# TECHNICAL MEMORANDUM

## Utah Coal Regulatory Program

RE: South Fork Quitcupah 2R2S, Canyon Fuel Company, SUFCO Mine, Permit # C/041/0002, Task #3950

Flow data from the S. Fork of Quitchupah

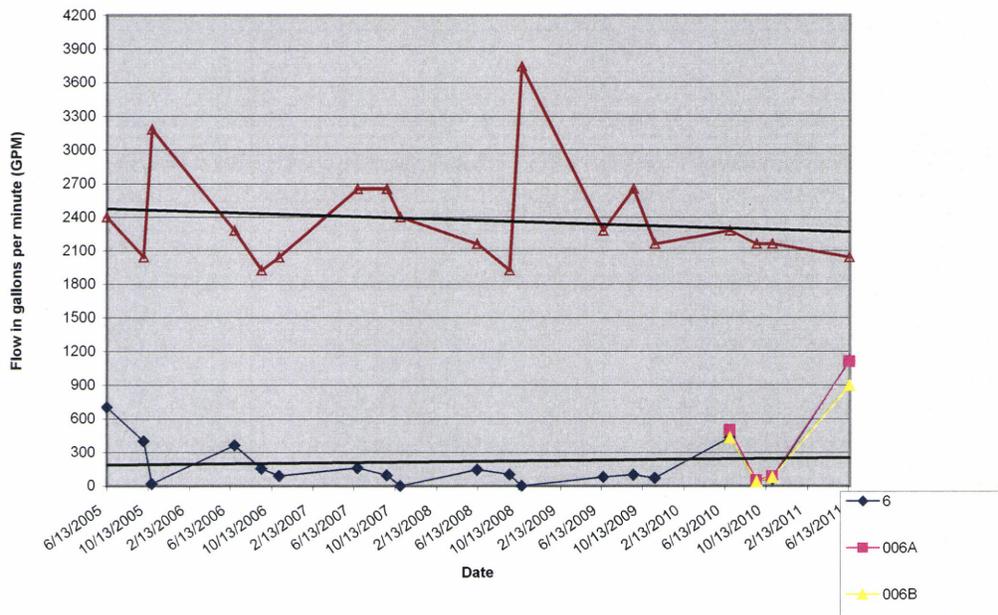
Currently, there are three surface water sampling locations monitored on a quarterly-basis along the south fork of Quitchupah Creek. Surface water sample location SUFCO 006 has been a historical stream monitoring location since June 1983. Two additional water monitoring points SUFCO 006A and 006B were added to the plan in June 2010. A third surface water sampling location is proposed for addition to the plan SUFCO 006C as part of this submittal. This location is intended to represent the downstream conditions. A mine water discharge outfall (UT-0022918-003A) is located approximately 1.5 miles further downstream and discharges water at an average constant rate of 6.75 cubic feet per second (cfs). Maximum flow rates from the South Fork of Quitchupah Creek reported from data point SUFCO 006 have been reported as 2 cfs (Table 7, Quitchupah/Muddy Creek CHIA Nov 2010). By comparison, the groundwater

discharge from the outfall location discharges at rates 12 times greater than the discharges rates measured upstream at SUFCO 006 (see graph below). Locations of these surface water sample locations are shown on Plate 7-3 of the SUFCO MRP.

## State of Utah Appropriated Water Rights

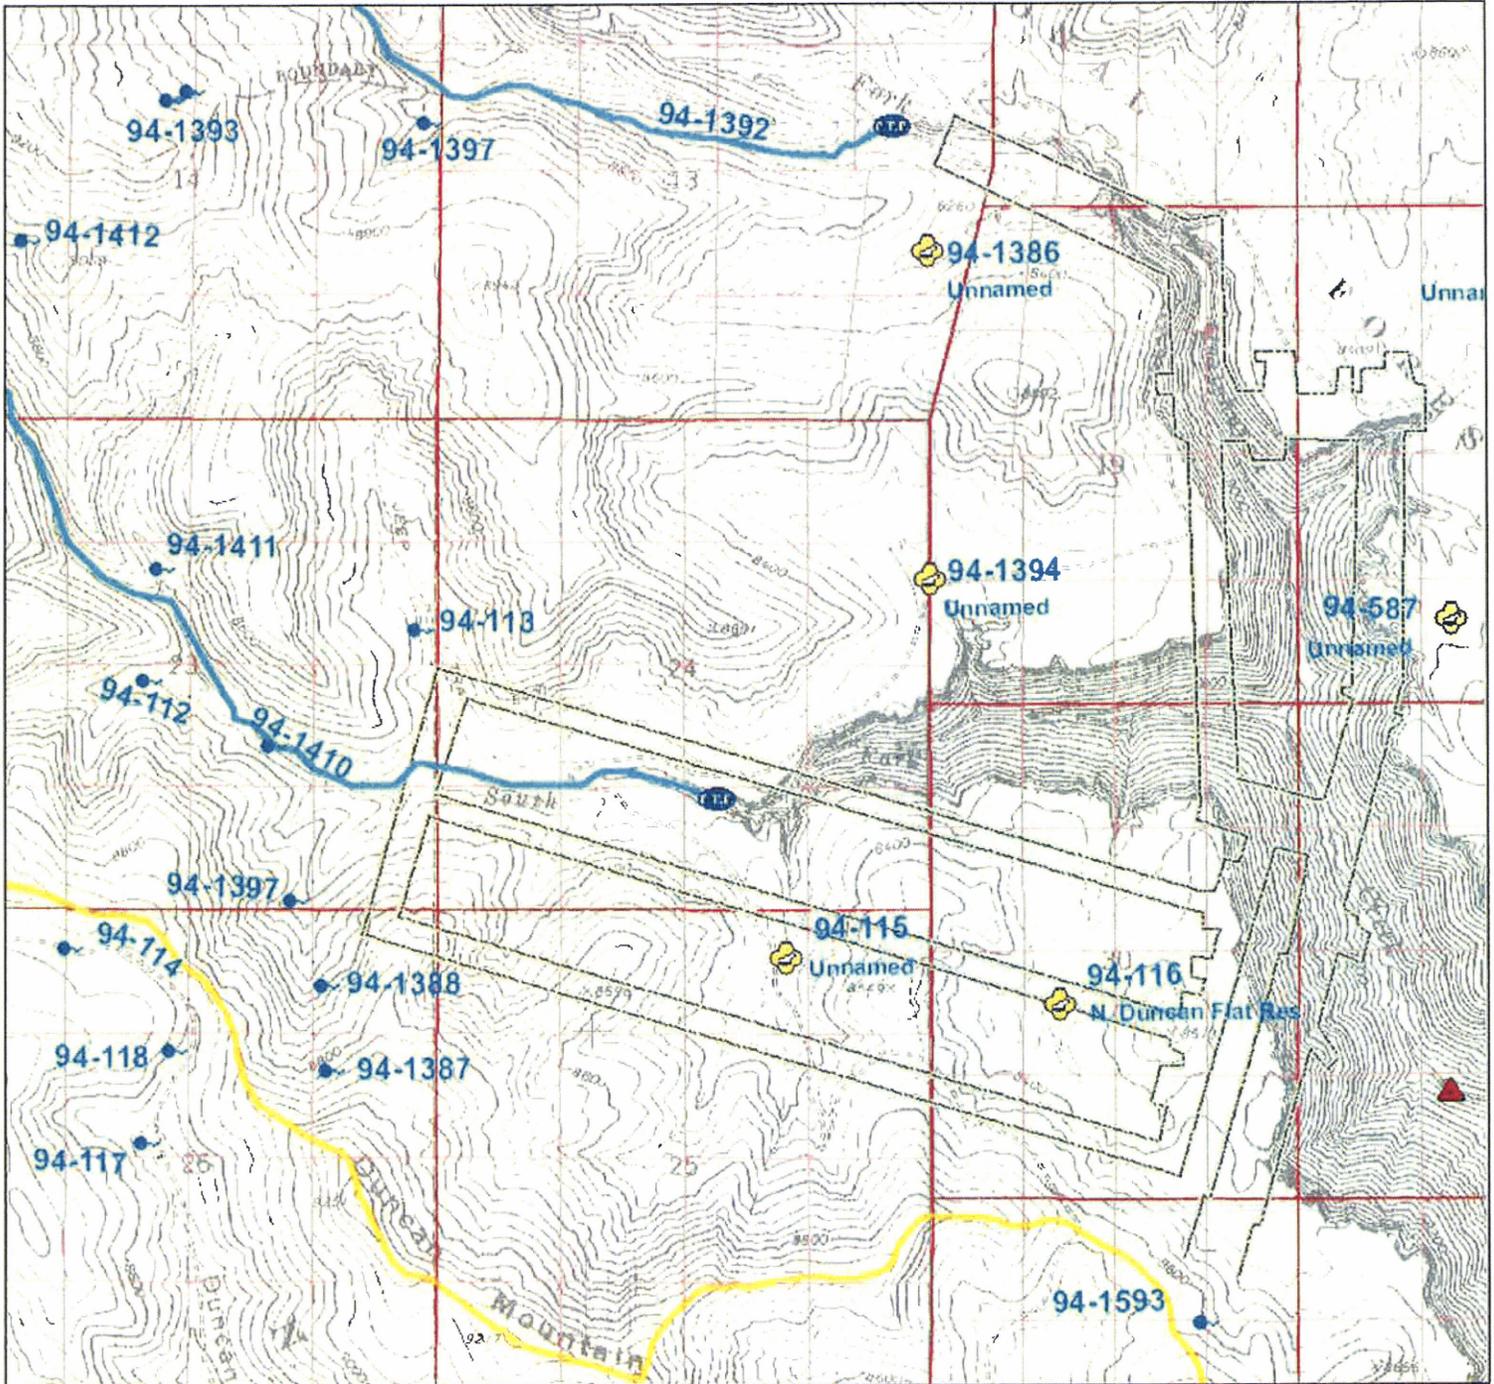
There are no spring sites that are actively monitored by SUFCO in the vicinity of the 2R2 panel (Sections 23, 24, 25, and 26 of T21S R4E). Water Rights have been identified on numerous springs and stockwatering ponds within this area (see map provided by the Division of Water Rights attached to this memo). These water rights are listed in Appendix 7-1 of the SUFCO MRP as being registered to the US Forest Service and all ultimately drain to the Muddy Creek Drainage. A total of 5 springs have been identified in Section 23, two springs in the northeast corner of Section 26 and one spring in the northeast corner of Section 24. None of these springs were discussed in the amendment submitted by SUFCO addressing any proposal to monitor these springs for baseline data requirements. These springs would be located outside of

Baseline data from springs, seeps and stockwatering ponds in the vicinity of the South Fork of Quitchupah Creek is absent. Several springs, seeps and stockwatering ponds do exist in the area based on the adjudication maps provided by the Division of Water Rights (DWRi).

On December 8, 2011, the Division received a response to a request for comments pertaining to this amendment from the Utah Division of Water Rights. The letter indicated that DWRi completed a review of the water rights near the proposed mine workings and provided a map of the water rights identified. The letter indicated that Quitchupah Creek and its associated drainage basin upstream from the major irrigation water uses are considered a fully appropriated water body. Point to point stock watering rights have also been identified in the subject area along the reach of stream identified on the map provided by DWRi. This means that water rights
